**ADDENDUM 1 TO FSR REGARDING WASTEWATER INFRASTRUCTURE
16-18 MILL ST, GEORGETOWN, ONTARIO**

File 30663J
May 05, 2023
16-18 Mill St, Georgetown ON
Addendum 1 to FSR

16-18 Mill St, Halton Hills

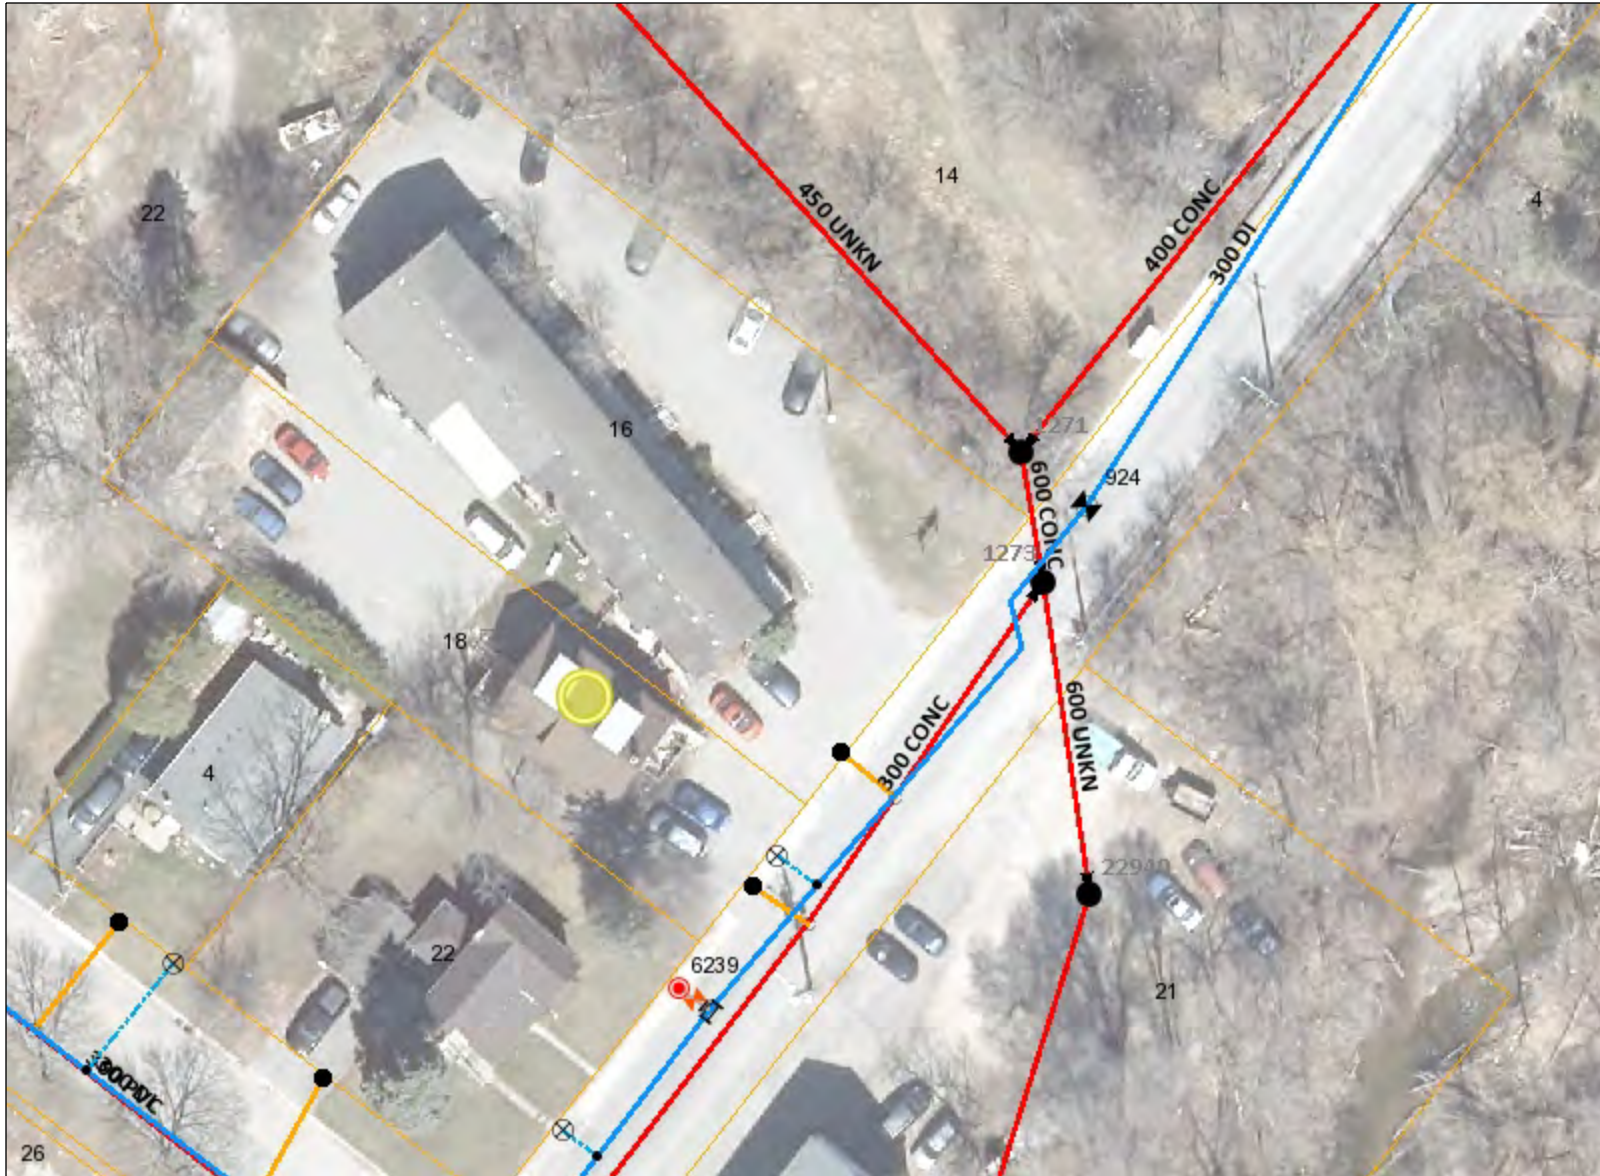
- i. outline of existing sanitary sewer system with any downstream constraints to be addressed;
- ii. sanitary sewer design sheets; and
- iii. provide internal and external Sanitary Area Drainage Plans.

The existing sanitary system in the area consists of a 300mm PVC sanitary wastewater main adjacent to the property along Mill Street, which flows into a 450mm diameter sanitary wastewater main adjacent to the property within a Regional easement. The map of the regional sanitary sewer is included in the Appendix.
